Project	IEEE 802.16 Broadband Wireless Access Working Group < http://ieee802.org/16 >
Title	STC Macro-Diversity Transmission
Date Submitted	2004-08-18
Source:	<p>HongSeok Choi, HeonIl Lee, ChongHo Park, Voice: 82-31-299-8263 Rocky HyongRock Park [Mailto :tonychoi@sktelesys.com] SK Telesys 4, pyeong-Dong, Gwonseon-Gu, Suwon-Si, Gyeonggi-Do 441-230, Korea</p> <p>KangIl Koh, SiHoon Ryu, Wonseok Jung, [mailto :melomo@sktelecom.com] JuSik Lee SK Telecom 9-1, Sunae-Dong, Pundang-gu, Sunnam City, Gyeonggi-Do 463-784, Korea</p>
Re:	IEEE 802.16e D4
Abstract	This contribution proposes STC Macro-Diversity Transmission.
Purpose	To incorporate the changes here proposed into the 802.16e D4 draft.
Notice	This document has been prepared to assist IEEE 802.16. It is offered as a basis for discussion and is not binding on the contributing individual(s) or organization(s). The material in this document is subject to change in form and content after further study. The contributor(s) reserve(s) the right to add, amend or withdraw material contained herein.

STC Macro-Diversity Transmission

Figure xxx - Illustration of STC for optional zones in DL

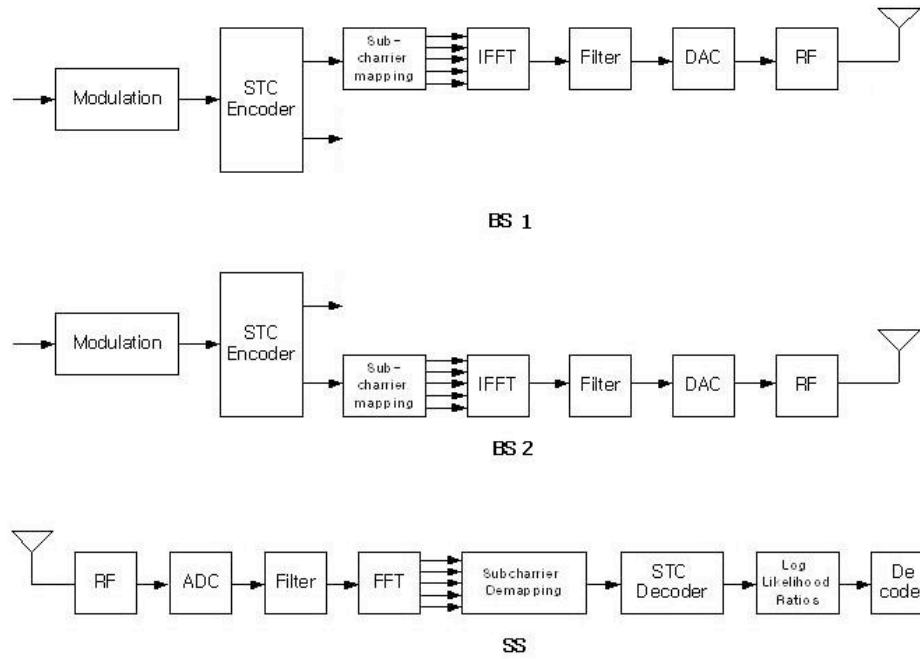
[\[Insert the following text before section 8.4.9\]](#)

Figure xxx shows an illustration of STC macro-diversity transmission. BS1 transmits only the half signal to be transmitted from antenna 1 to SS and BS 2 transmits the other half signal. The total amount of signal processing in all BSs is same as that of normal case without STC macro-diversity. But hardware complexity for example antennas can be reduced by half. Also diversity gain can be increased by better channel coherency between different BSs.

Figure yyy - Illustration of STC for optional zones in DL

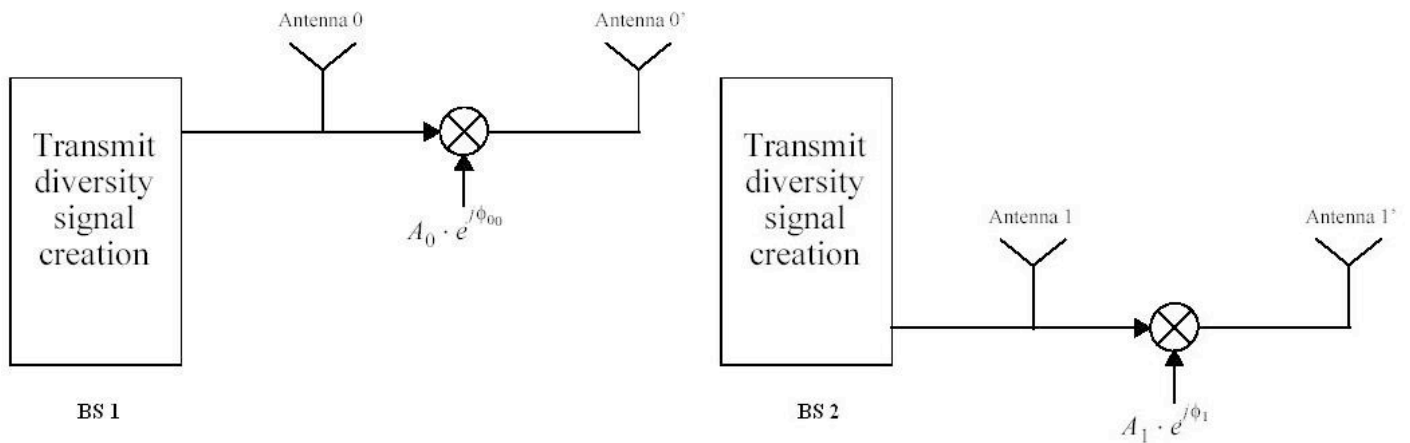
Figure yyy shows an illustration of STC macro-diversity transmission using 2 antennas in each BS. It gives hardware complexity reduction, for example the number of antenna could be reduced by half. And diversity gain can be increased compared to the case without macro-diversity.
